JRPP No:	2014SYE002
DA No:	DA13/1192
LGA:	Sutherland Shire
Proposed Development:	Construction, Fit-Out and Use of a Building as a Shop with Basement Parking
Site/Street Address:	Lot A, Lot B, Lot C & Part Lot D DP 373329 and Part Lot B DP 373473 28 – 38 Flora Street, Kirrawee
Applicant:	Macroplan Dimasi
Submissions:	5
Recommendation:	Refusal
Report By:	Brad Harris, Environmental Assessment Officer - Planner Sutherland Shire Council

Assessment Report and Recommendation

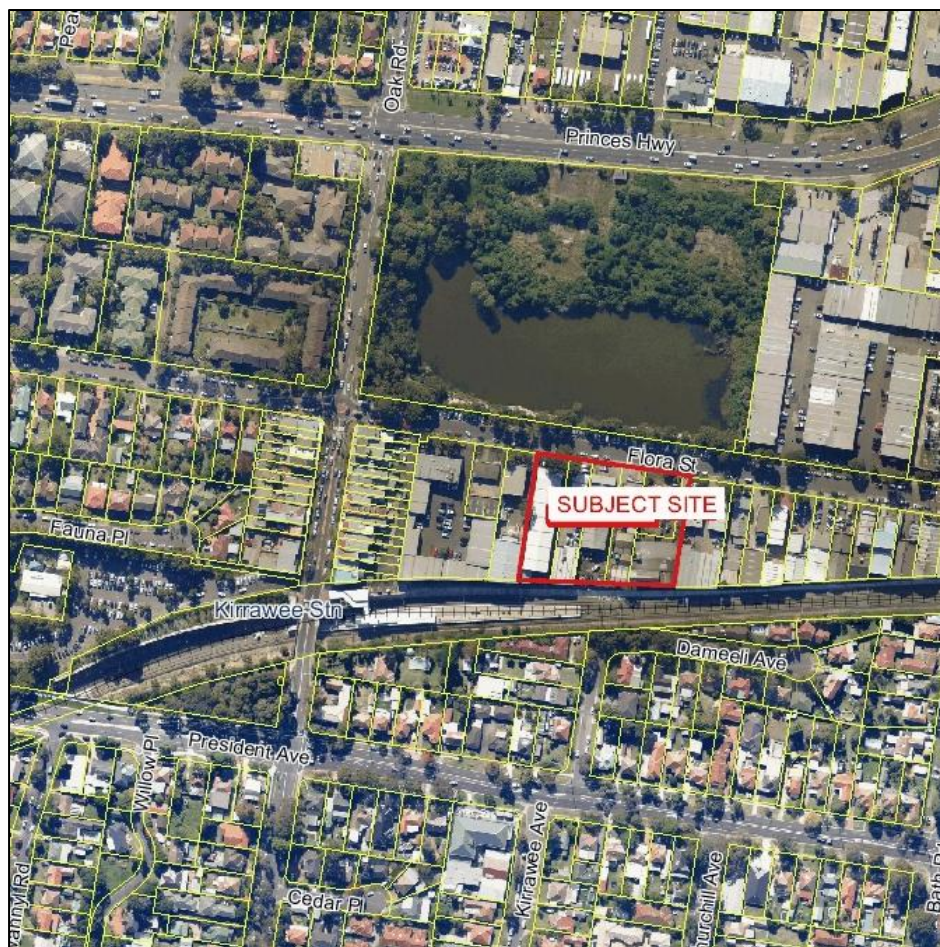
The main façade of the proposed building maintains setbacks of 6m and 12m to Flora Street. The 12m setback incorporates the truck manoeuvring area, which extends for approximately 40% of the frontage of the site. This, coupled with the two (2) additional driveway crossings into the site for customer parking, represents a poor urban design outcome that the applicant has struggled to resolve on-site due to constraints associated with grades, loading clearances and the desired retail yield. Council's preference for trucks to 'cycle' around the rear of the building was not pursued by the applicant as this would lead to trucks clashing with customer vehicles.

The setback of 11m to the eastern side boundary incorporates the service driveway accessing the loading dock, and a 19m setback to the western side boundary makes provision for an at-grade parking area and driveway access to the basement parking area. A 1m setback is provided to the rear boundary, which adjoins a railway corridor, whereas Council's DCP requires a much more significant setback to the railway, including an area of vegetated public open space (for all sites on the southern side of this part of Flora Street).

The proposed development provides three (3) separate vehicular access points off Flora Street and includes a truck manoeuvring area at the street frontage. This is considered highly undesirable from a streetscape point of view as more than 30% of the built form at the street alignment is interrupted by driveway openings. This is unsatisfactory from a traffic and pedestrian safety perspective and does not contribute to a highly active commercial frontage as anticipated by the zone objectives in SSLEP 2006 or the urban design outcomes of SSDCP 2006.

Further the scale of the building, together with three (3) separate driveways and a large truck turning area at the street frontage, results in a significant 'missing tooth' effect in the streetscape which is intended under SSDCP provisions to be primarily a commercial precinct with an active streetscape at street level and residential development above. The current planning controls provide for three (3) storey development on the site, and greater heights have been considered under Council's draft LEP; whilst six (6) storeys have been approved across the street on the Brick Pit site (where significantly increased heights of up to 14 storeys fronting Flora Street are currently under assessment).

- A reduced store area.
- An increased rear setback.
- Redesign and relocation of the vehicle manoeuvring area.
- Improvements to the building's design and landscaping/street planting to improve the interface with the public domain.
